# Access Compliance Report

## Public Rights-of-Way

Intersection ID: 17675	Main Street: DONEGAL_DR	Cross Street: RAMA_RD	Location: S
ADA ID: 442A2604F332	Ramp Type: PerpDiag	Initial Pass/Fail: Fail	Overall Compliance: No
Severity Score: 21.25			
Codes/Mitigation Info/Possible Solution		Field Measurements/Component Compliance

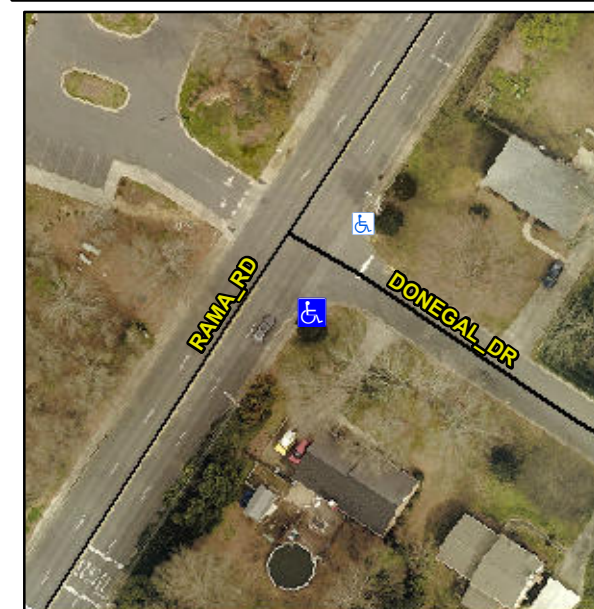
**Not Found, R304.5.1, R304.5.3**

Compliance	Description	Data	Compliance	Description	Data
N/A	Ramp Length (in)	60.0	Yes	Ramp Slope (%)	7.7
No	Ramp Width (in)	45.0	No	Ramp XSlope (%)	6.3
N/A	Flare Type LT	N/A	N/A	Flare Type RT	N/A
N/A	Flare Slope LT (%)	N/A	N/A	Flare Slope RT (%)	N/A
N/A	Flare Traversable LT?	N/A	N/A	Flare Traversable RT?	N/A
N/A	Landing Length (in)	N/A	N/A	DWS Provided?	N/A
N/A	Landing Width (in)	N/A	N/A	DWS Contrast?	N/A
N/A	Landing Slope (%)	N/A	N/A	DWS Length (in)	N/A
N/A	Landing X Slope (%)	N/A	N/A	DWS Full Width?	N/A
N/A	Landing Curb? (Y/N)	N/A	N/A	DWS Offset (in)	N/A
N/A	Shared Landing?	N/A			
N/A	Gutter Ponding?	N/A	N/A	Gutter Slope (%)	N/A
N/A	Gutter Lip Ht (in)	N/A	N/A	Gutter X Slope (%)	N/A
N/A	Painted X Walk1?	No	N/A	Painted X Walk2?	No
	X Walk 1 Direction	To NE		X Walk 2 Direction	To NW
N/A	X Walk 1 Width (in)	N/A	N/A	X Walk 2 Width (in)	N/A
	X Walk 1 Slope (%)	2.5		X Walk 2 Slope (%)	8.8
	X Walk 1 X Slope (%)	8.2		X Walk 2 X Slope (%)	1.2

**Remove & Replace Curb Ramp With Two New Directional Ramps or Equivalent.**
